CITY PLANNING COMMISSION

- APPLICATION:
- A. Negative Declaration
 - B. Plan Review of 32 unit apartment complex
 - C. Lot Line Adjustment to merge two lots

PROPOSAL: The applicant is requesting the necessary entitlements to construct a 32 unit apartment complex.

APPLC. NO. P85-309

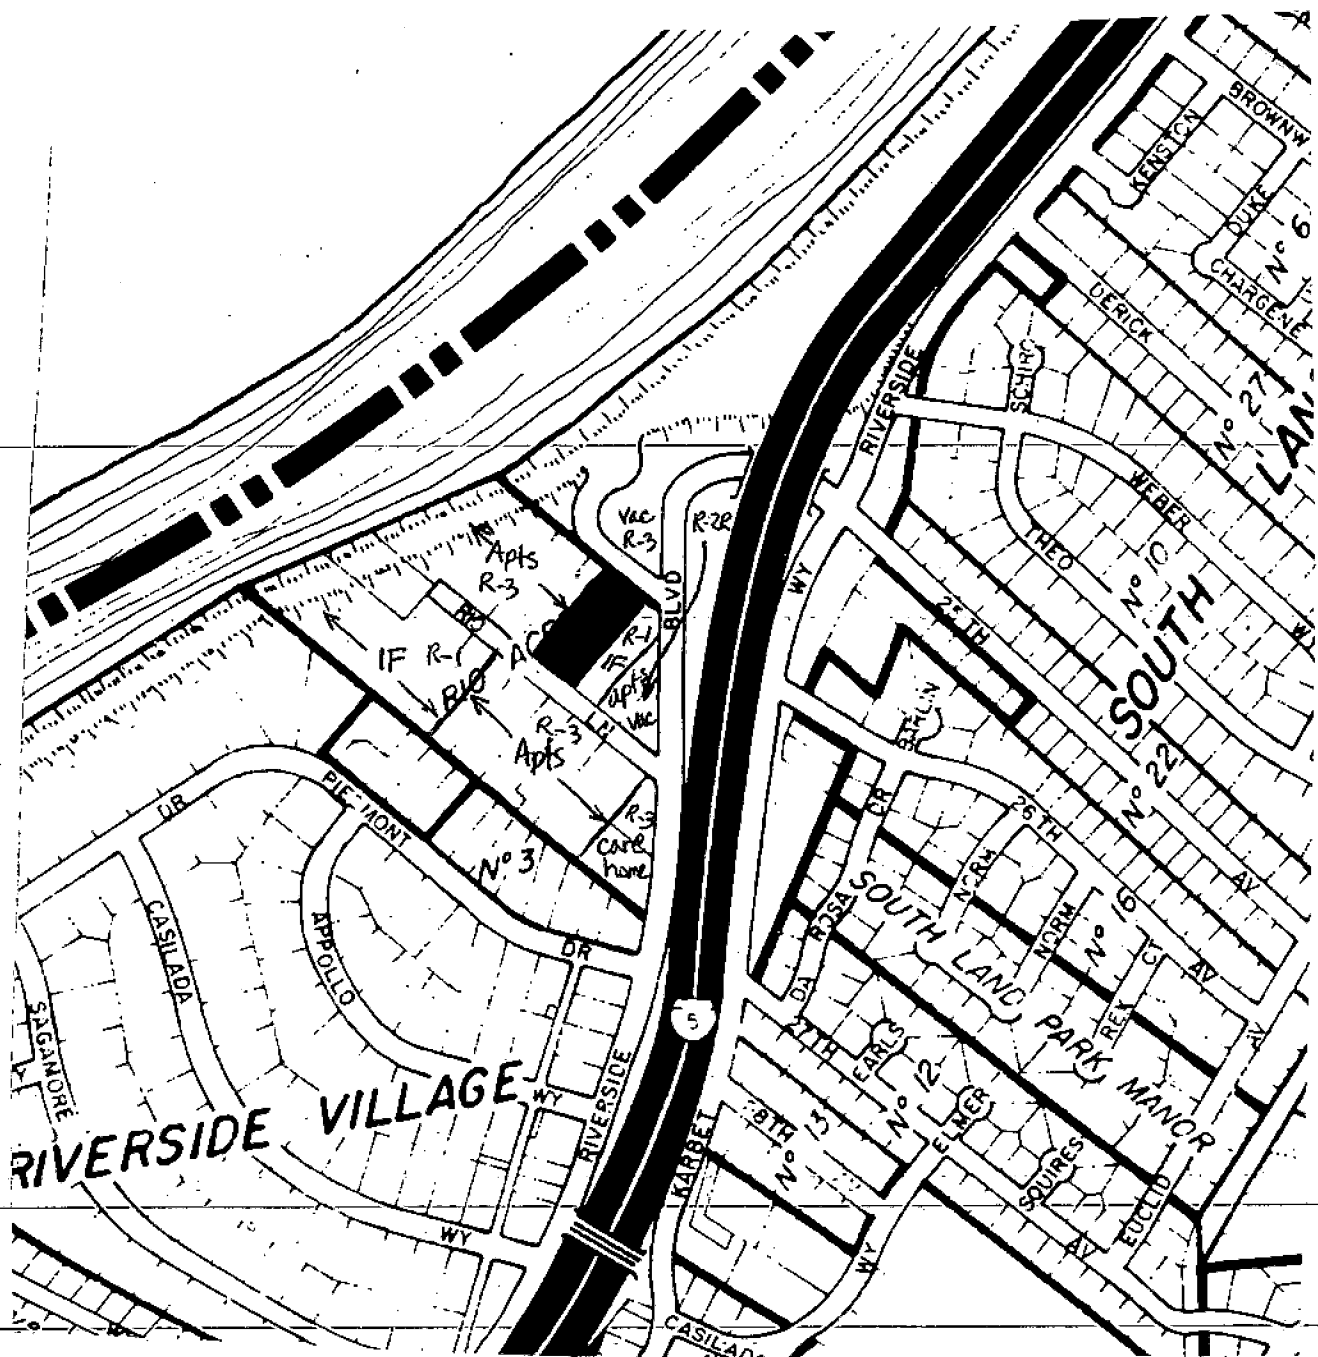
1. It is likely that the relationship of the parking lot and the units located along Rio Lane will create a situation where the tenants will park along Rio Lane which would be a shorter walking distance than the parking lot. A field survey of the Rio Lane area indicates that many of the apartment tenants and their guests park on the street. Staff recommends that either the parking layout or the units along Rio Lane be relocated in the manner outlined in Exhibit B (A.2.).

2. The site plan does not indicate the location of the trash enclosures. The enclosures must be constructed and located in the manner outlined in Exhibit B (F). In addition, the applicant is required to provide five bicycle storage lockers on-site in accordance with the criteria outlined in Exhibit B (D).

Traffic: Maximum 4% slope within 20 feet of public right-of-way (Captain's Table Road). Captain's Table Road and Riverside Boulevard roadways are not shown in true alignment.

- 1. The applicant shall submit a revised site plan indicating the relocation of units and parking area for review and approval by the Planning Director prior to the issuance of building permits.

Lot Line to be removed

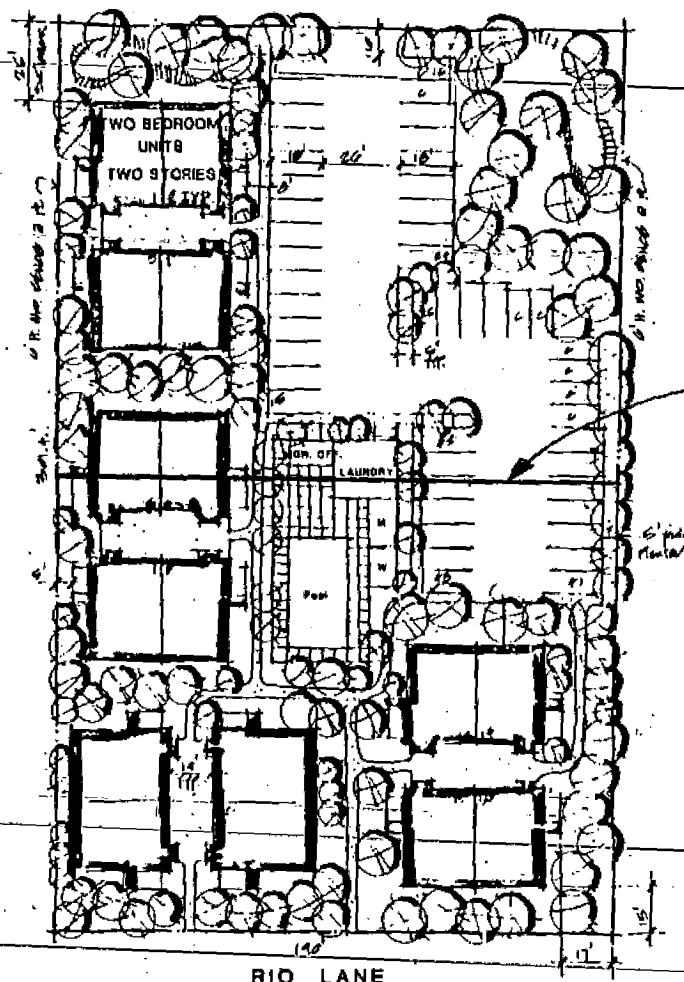
5. Staff is including multi-family site development criteria to be conditions of approval of this project (See Exhibit B).
- D. The applicant's project will also necessitate the processing of a lot line adjustment to merge the two lots. Staff has no objections to the proposed lot line merger.
